Proposal for a new UN Regulation on uniform provisions concerning the approval of motor vehicles with regard to the Moving Off Information System for the Detection of Pedestrians and Cyclists**Submitted by the Informal Working Group on Awareness of Vulnerable Road Users proximity in low speed manoeuvres**

The text reproduced below was prepared by the Informal Working Group (IWG) on Awareness of Vulnerable Road Users proximity in low speed manoeuvres (VRU-Proxi) to establish a new UN Regulation on Moving Off Information Systems (MOIS) intended to be fitted to heavy vehicles to protect vulnerable road users. It provides the state of play of the discussions held by the informal working group throughout 2019. It aims at providing the experts of Working Party on General Safety Provisions (GRSG) the opportunity to react, comment and contribute to work performed by the informal working group in advance of the 118th session of GRSG.

Green: OICA-CLEPA proposals or comments (28th January 2020) - OICA-CLEPA review still under progress

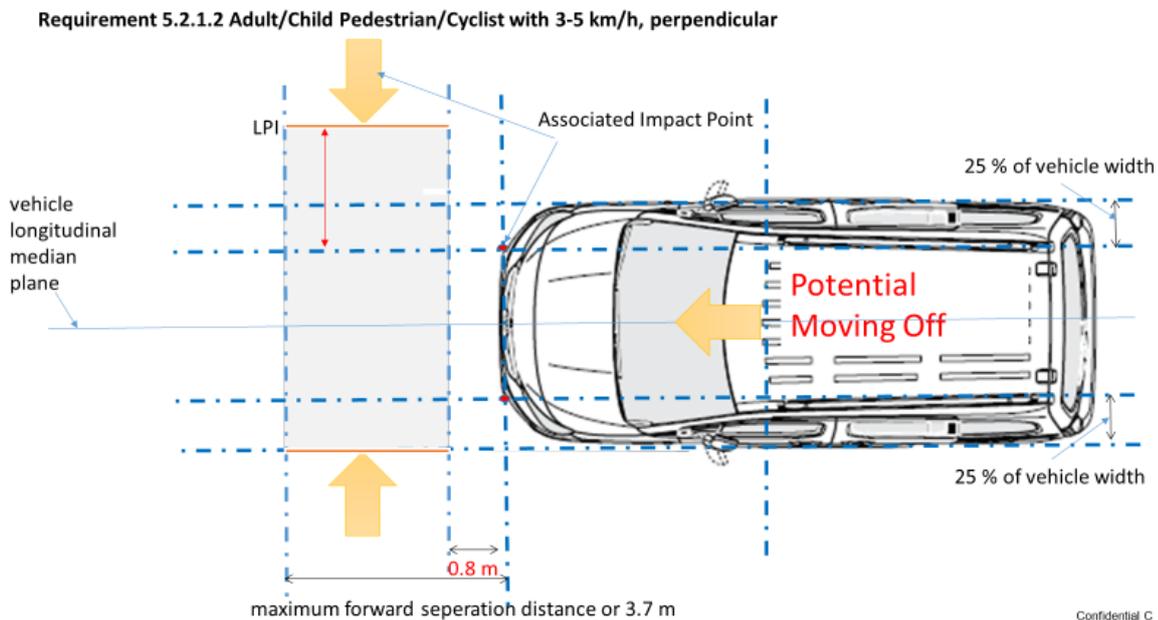
OICA 22/01/2020: Should not be symmetric as offside, you have a better view, the VRU would have already crossed one road lane

Reference to Test cases (§) to be added for clarification

Instead of the LPI on the nearside, we would also support a maximum nearside lateral separation distance with the same idea as for the maximum forward separation (Head of the child pedestrian dummy can be seen) => proposal under construction.

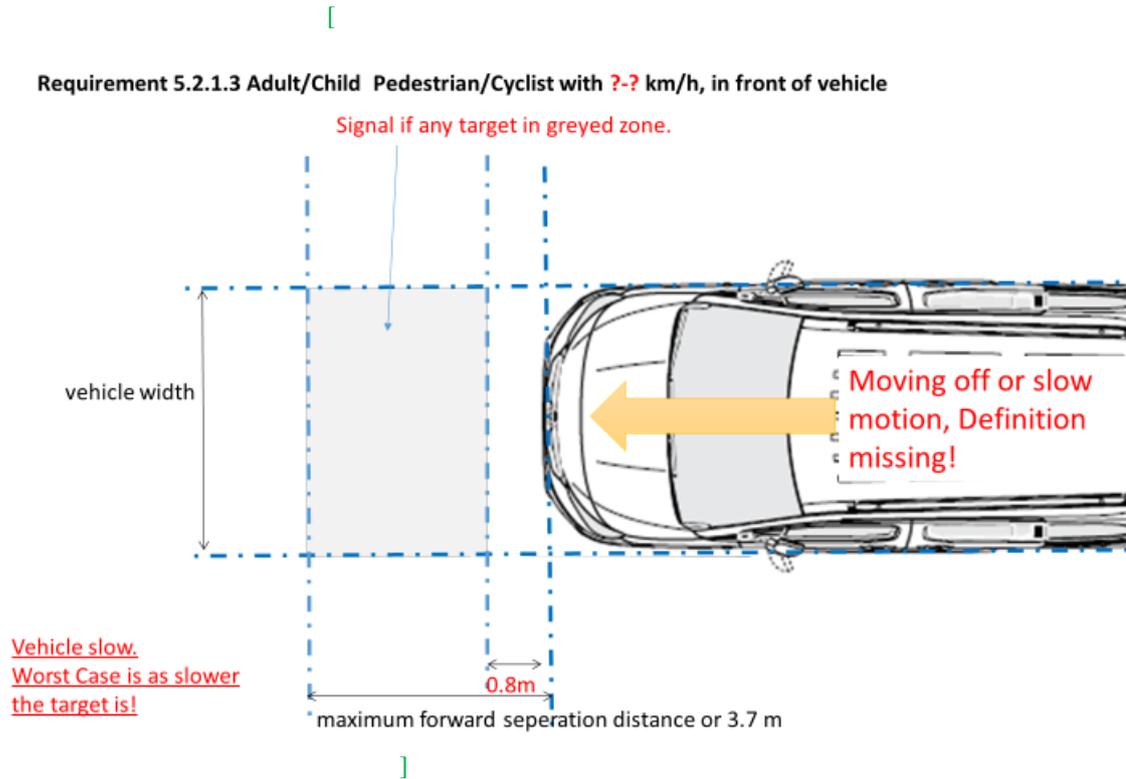
OICA 20/01/2020: Reference to Test cases (§) to be added for clarification

Is this 0 to 5 km/h for or is this 3 to 5 km/h ? What are all operational speeds? **Vehicle speed**

Fast VRU that touches this area aren't a threat especially to limited acceleration capability of M2/N2/M3/N3 vehicles. Therefore information is not necessary in this case.

MOIS SCENARIO II Cyclist Moving OFF (§6.6)

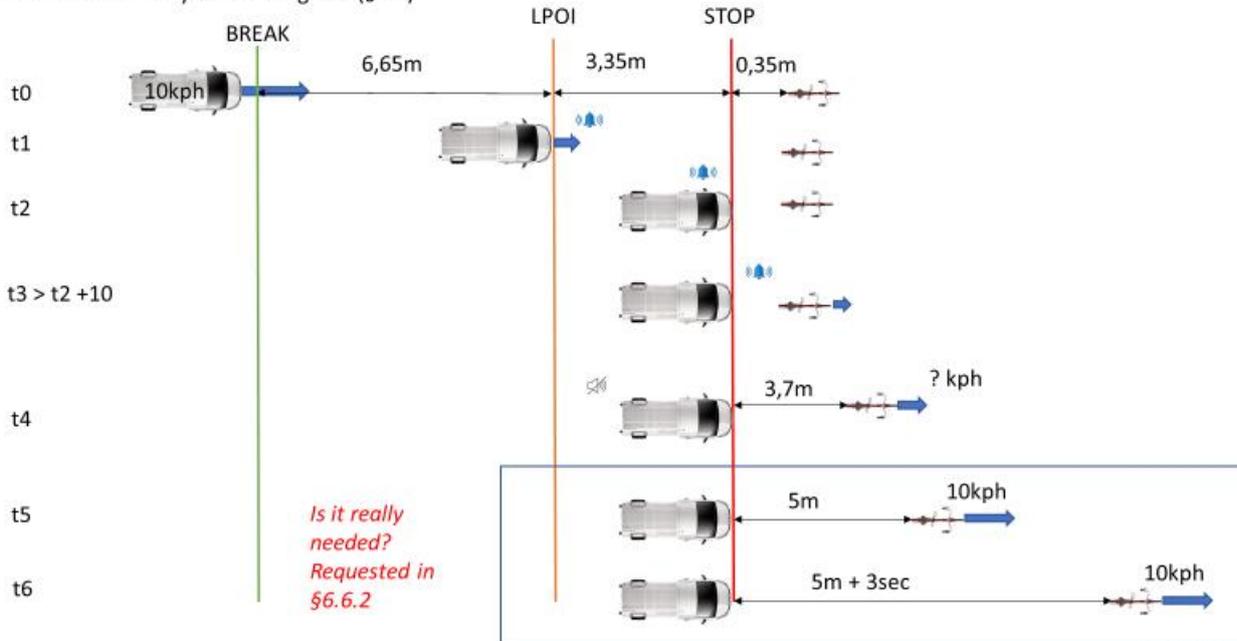
10 ± 0.5 km/h is in conflict with the requirement which is up to 10 kph (5.2.3)

Lateral tolerance proposal to be in line with NCAP measure

6.6.2 needed as no requirement in section 5 in line with 6.6.2?

Figure 1
Set Up for Static Crossing Tests

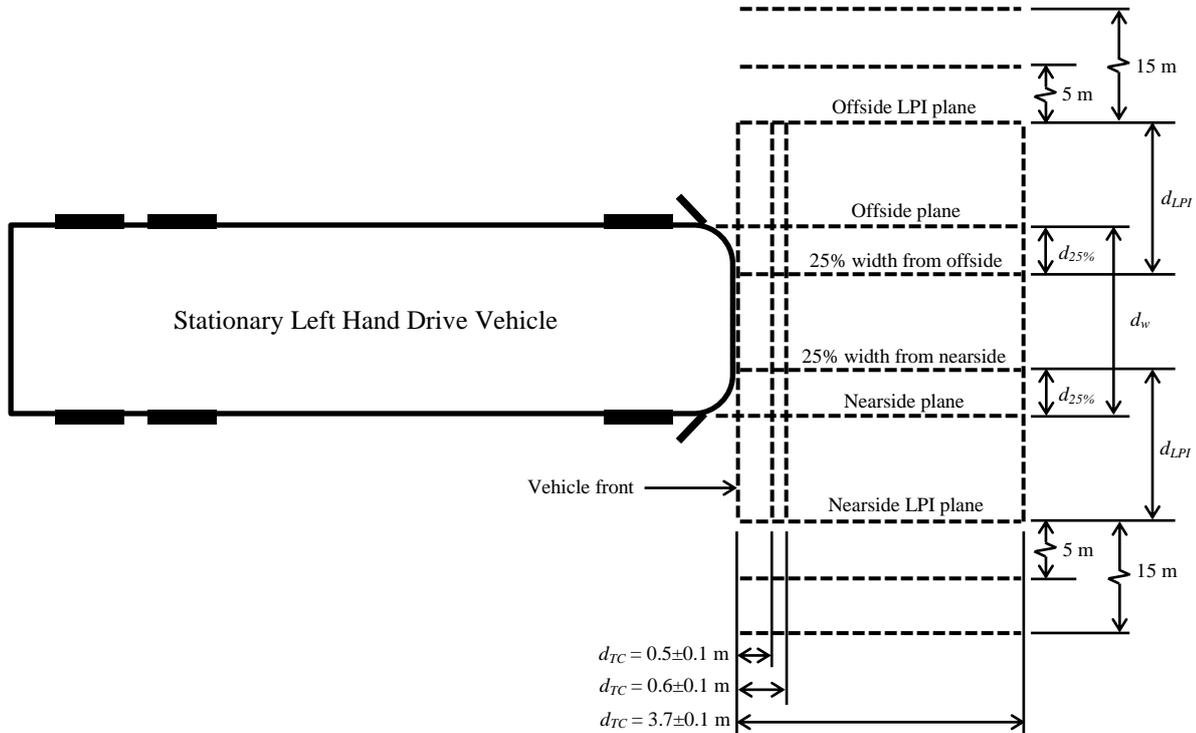
OICA 28/01/2020: 1.9 is equivalent to 1.4s at 5 kph
